California Department of Transportation

11-SD-15
PM M23.00

Rancho Bernardo Health Center Medical Office Building,
UCSD Response to Comments
MND/SCH#2024041069

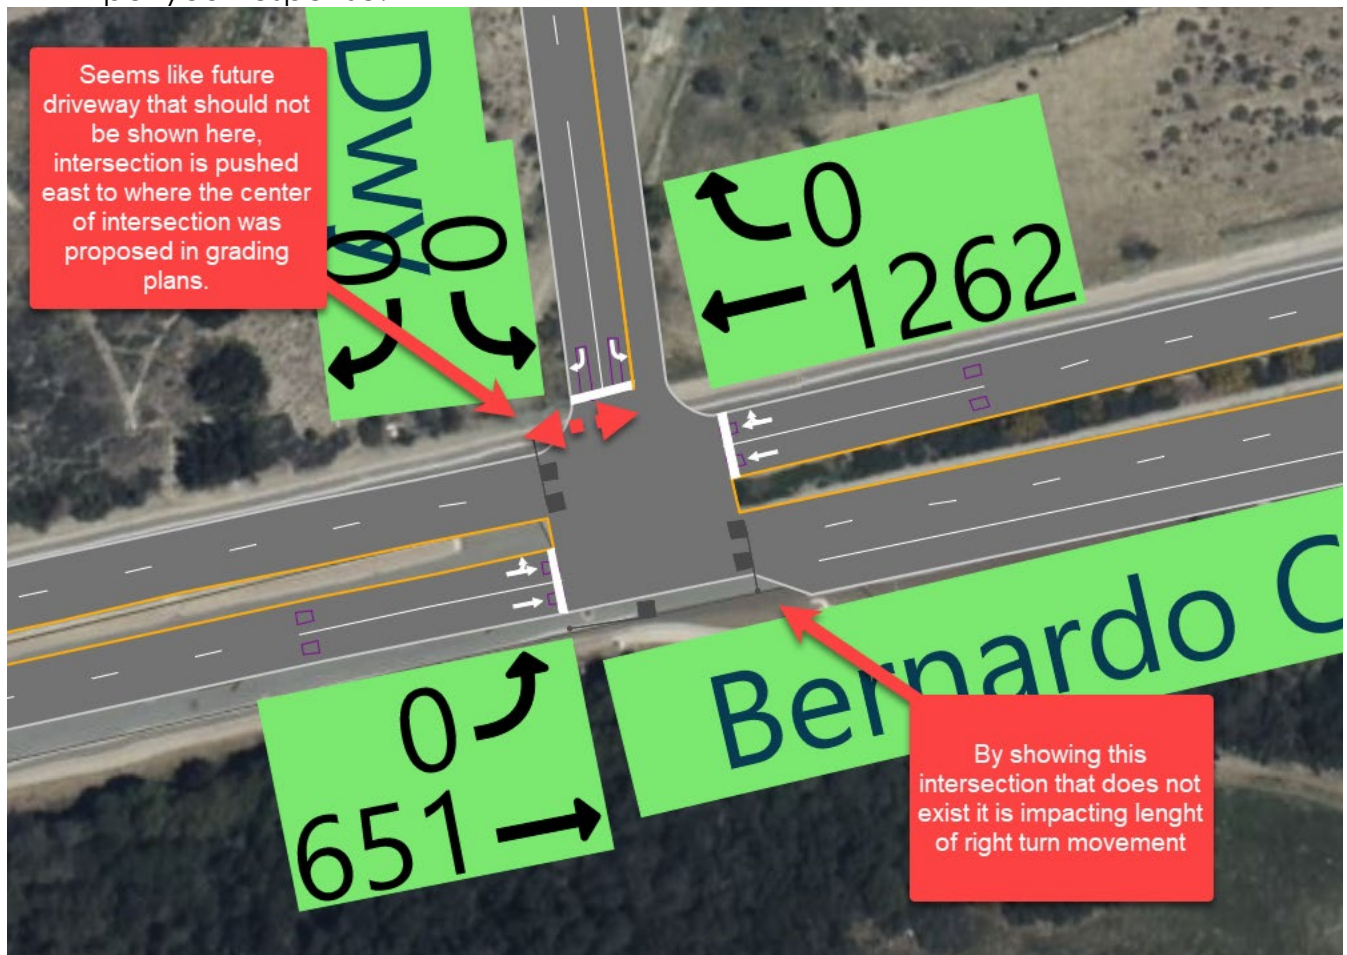
- Response A2-5: Synchro model was reviewed again, and model of existing condition should not show a signalized intersection where there currently is none, even if signal is phase in green for through movements and no trips are shown going or coming from a driveway that should not exist.
 - By showing the signalized intersection in existing condition there are impacts shown that would possibly impact study. Remove intersection from Synchro Model Existing and Near-Term scenarios. Even if signal and trips are turned off per your response.

- Previous comment still applies: The Existing condition has included the proposed intersection that does not exist. Need to remove for Existing and Near Term.
- Further Synchro review shows that the model needs to be corrected for errors and the Sim traffic calibration for 60 minutes duration to capture peak hour, it is set to 10 minutes.

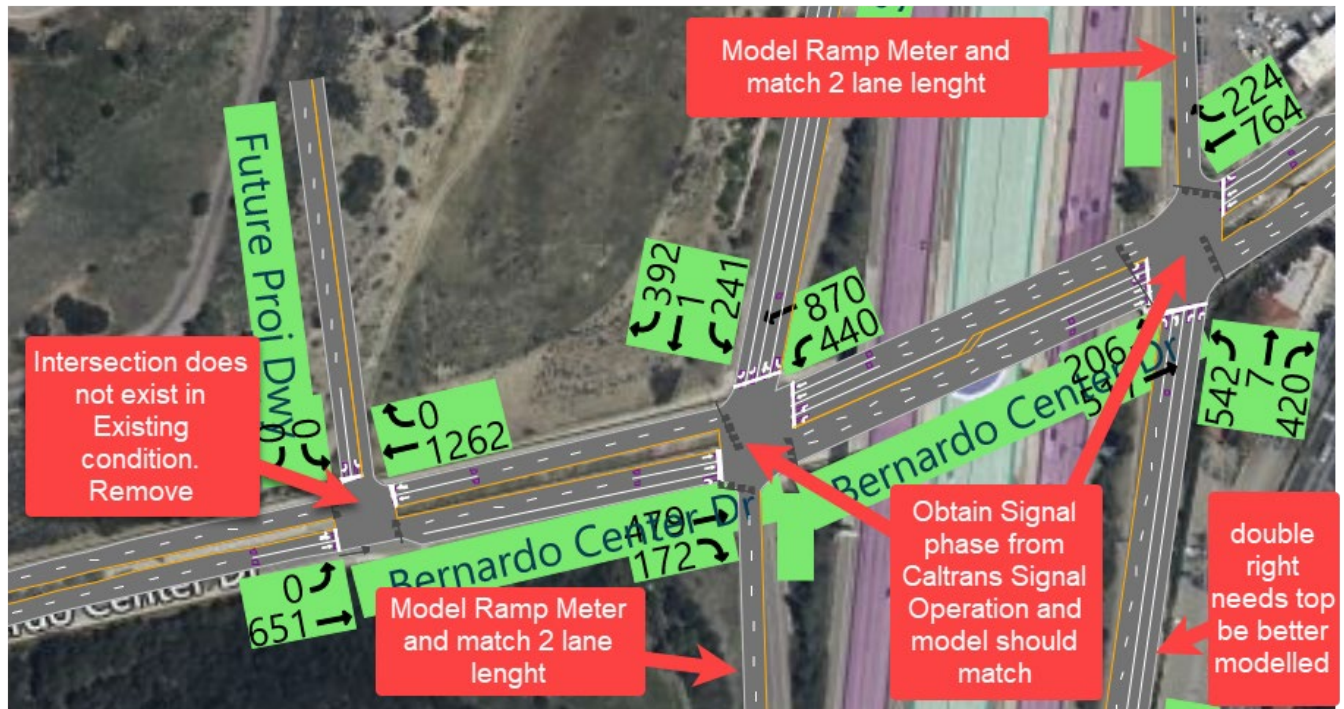
- Response A2-8: This response does not satisfy Caltrans comments therefore comments still apply. See comments on response above.
 - Not all Caltrans Traffic comments were addressed:

- Synchro model comments still apply, and revised model is required.
 - Also, ramp meter should be modelled during peak hours.

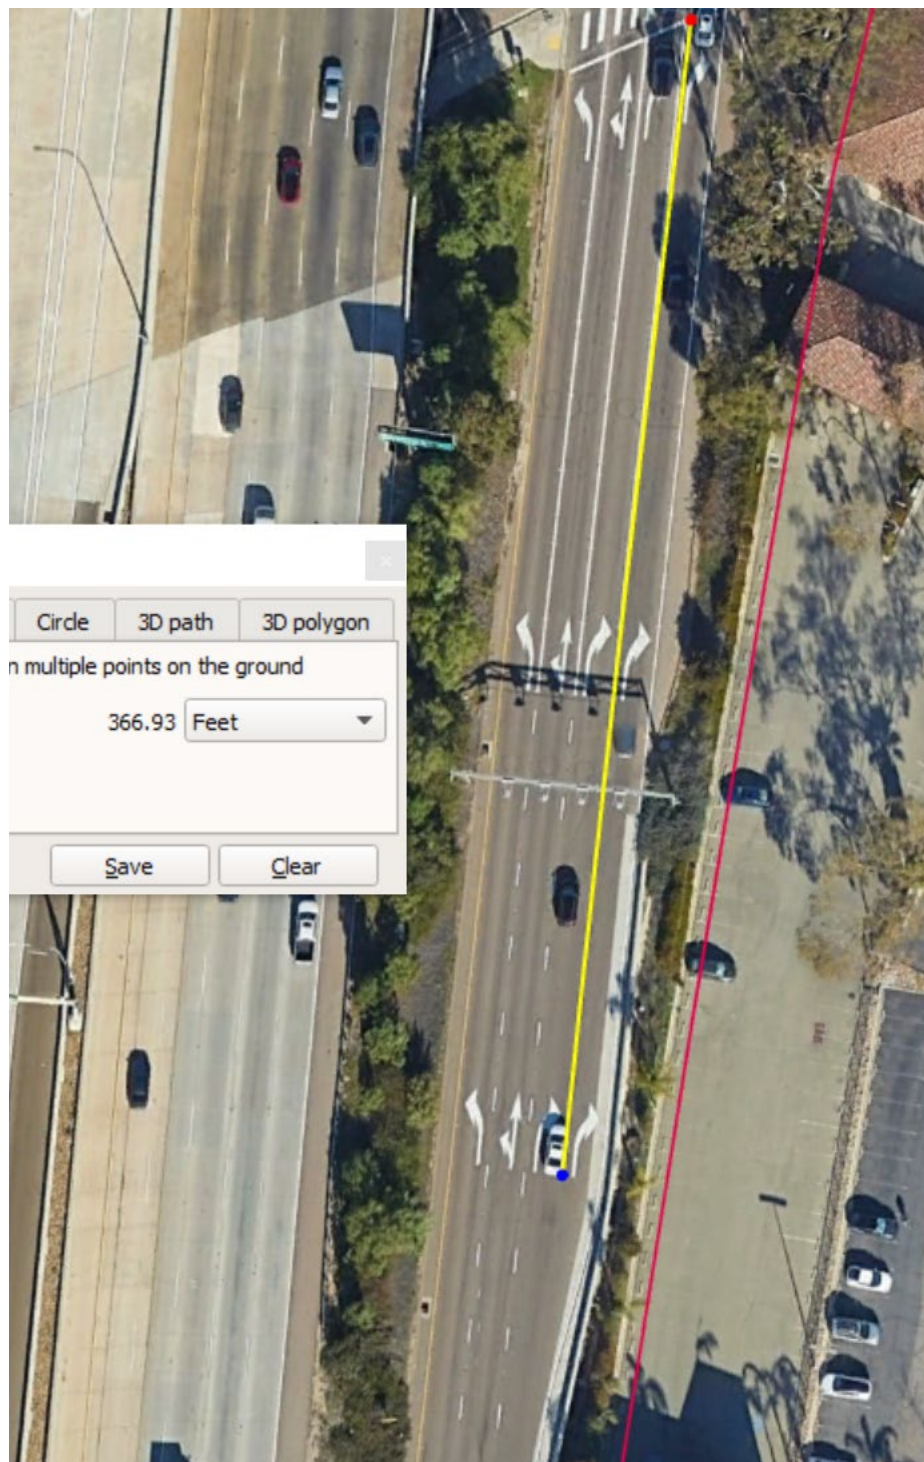
- The Synchro model needs to be updated and the sent to us for review. Then update LMA and resubmit to us for review.

- Ramp meter lane configuration needs to be modelled and shown.
